From: Joann Minko <joannjmm@yahoo.com>
Sent: Tuesday, July 18, 2023 9:00 AM
To: Zoning <zoning@cityofmadison.com>
Subject: Concerns over 4809 hillview terrace plan

As we look more into the proposed addition, we ask that the setback decision be paused until the safety and security of the proposed retaining wall next to our property can be determined by an engineering assessment. A change in retaining wall locations will impact the garage structure and location.

Our 5 year old measuring the 4 foot retaining wall at the plot line and sidewalk

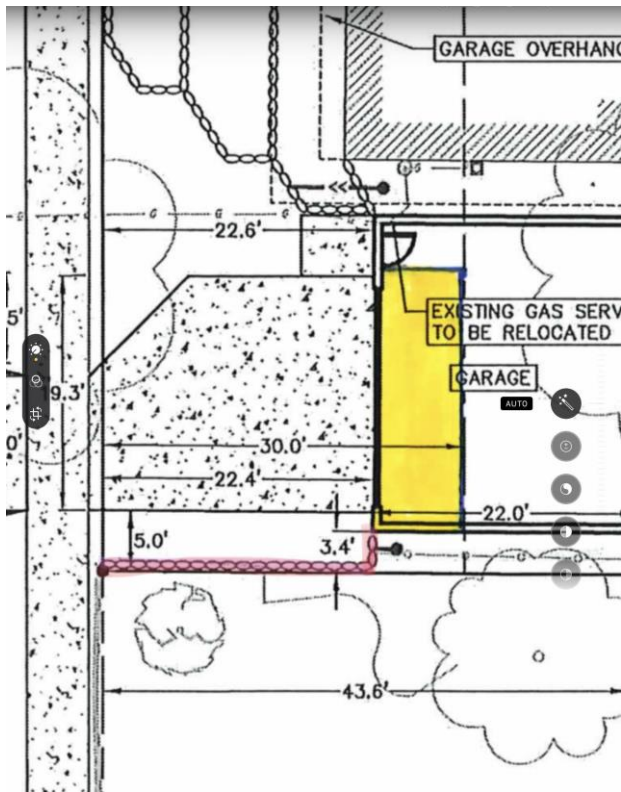
The proposed wall is to go from 4 feet at street level up to garage height at top, with our property sloping down into the retaining wall. An engineered retaining wall will take up feet of space that is not accounted for in the plans and is vital to safety of the overall plan. We do not give permission for any part of the retaining wall nor its backfill, deadman poles.... to be within or under our property.

Having a 4 foot and taller retaining wall along the driveway creates a serious safety hazard for the neighborhood. Drivers coming out of the driveway would have trouble seeing people, especially those with young kids and dogs. The average kid reaches 4 feet around age 7. There are at least 13 kids under the age of 10 within a block of the proposed driveway plus our sidewalk frequently is used by people walking with kids and/or dogs. People walking along the sidewalk would be unable to see someone backing out of the proposed driveway until the car nearly reached the sidewalk. The steepness of the sidewalk would make it even more dangerous for little kids using balance bikes out on a walk with their families or parents using strollers as it would take longer for them to stop. As well, this would cause us to be out of compliance with Madison driveway viability and liable to fines and such for at least 5 feet along the street, under the current plan.

2. We have significant concerns about having an 8-12foot drop off on the side of our property. We have 3 little kids at home, who all enjoy playing in the front yard with neighborhood kids as well as gardening. Falling from such a height, onto concrete, would cause serious injury or death. The answer is also not as simple as a fence for the reasons of code and liability. A terrace system could work but a retaining wall engineer would need to make than determination.

Location of proposed retaining wall that we are concerned with in red. It is 4 feet at the sidewalk and goes up to the height of the garage.

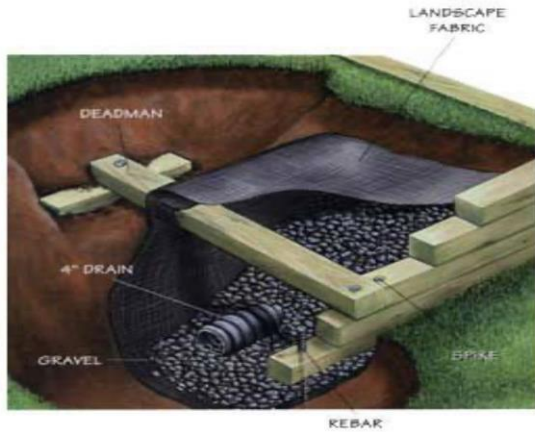
Car pictured in proposal couldn't see a child walking by retaining wall. Retaining wall parallel with plot line is minimum 4 feet, much higher than the 2.5 feet maximum within 10 feet, needed for safety as determined by the city of Madison.

Types of Retaining Walls

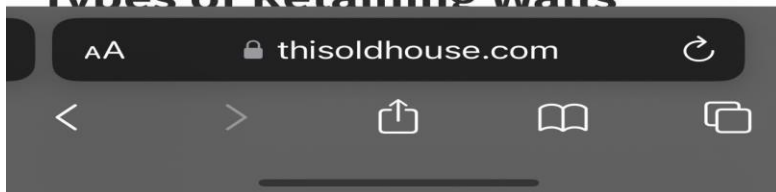
Here an 8 foot retaining wall would need 8 feet of setback for support
